Access Compliance Report

Public Rights-of-Way

Intersection ID: 47836	Main Street: ALVARADO_WY	Cross Street: DRAGONFLY_LN	Location: W
ADA ID: 21194D0128F0	Ramp Type: Perp	Initial Pass/Fail: Fail	Overall Compliance: No
Severity Score: 21.25			
Codes/Mitigation Info/Possible Solution		Field Measurements/Component Compliance

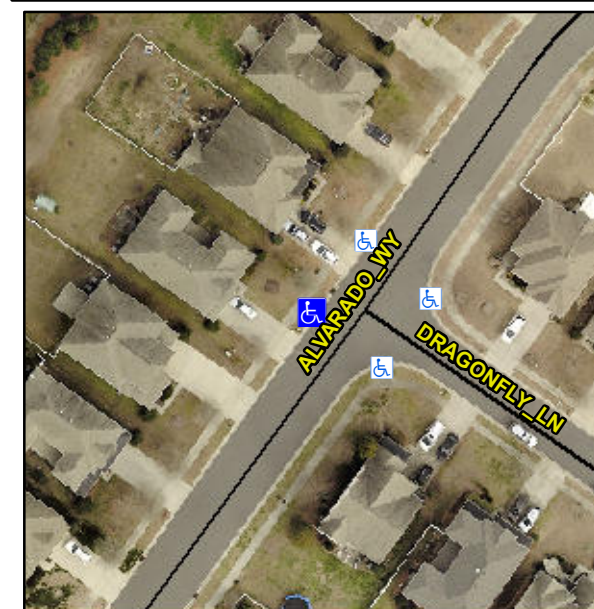
Not Found, R304.5.1, R304.2.2

Compliance	Description	Data	Compliance	Description	Data
N/A	Ramp Length (in)	72.0	No	Ramp Slope (%)	11.2
No	Ramp Width (in)	47.0	Yes	Ramp XSlope (%)	1.8
N/A	Flare Type LT	N/A	N/A	Flare Type RT	N/A
N/A	Flare Slope LT (%)	N/A	N/A	Flare Slope RT (%)	N/A
N/A	Flare Traversable LT?	N/A	N/A	Flare Traversable RT?	N/A
N/A	Landing Length (in)	N/A	N/A	DWS Provided?	N/A
N/A	Landing Width (in)	N/A	N/A	DWS Contrast?	N/A
N/A	Landing Slope (%)	N/A	N/A	DWS Length (in)	N/A
N/A	Landing X Slope (%)	N/A	N/A	DWS Full Width?	N/A
N/A	Landing Curb? (Y/N)	N/A	N/A	DWS Offset (in)	N/A
N/A	Shared Landing?	N/A			
N/A	Gutter Ponding?	N/A	N/A	Gutter Slope (%)	N/A
N/A	Gutter Lip Ht (in)	N/A	N/A	Gutter X Slope (%)	N/A
N/A	Painted X Walk1?	No	N/A	Painted X Walk2?	N/A
	X Walk 1 Direction	To SE		X Walk 2 Direction	N/A
N/A	X Walk 1 Width (in)	N/A	N/A	X Walk 2 Width (in)	N/A
	X Walk 1 Slope (%)	3.1		X Walk 2 Slope (%)	N/A
	X Walk 1 X Slope (%)	1.2		X Walk 2 X Slope (%)	N/A

Remove & Replace Entire Ramp.
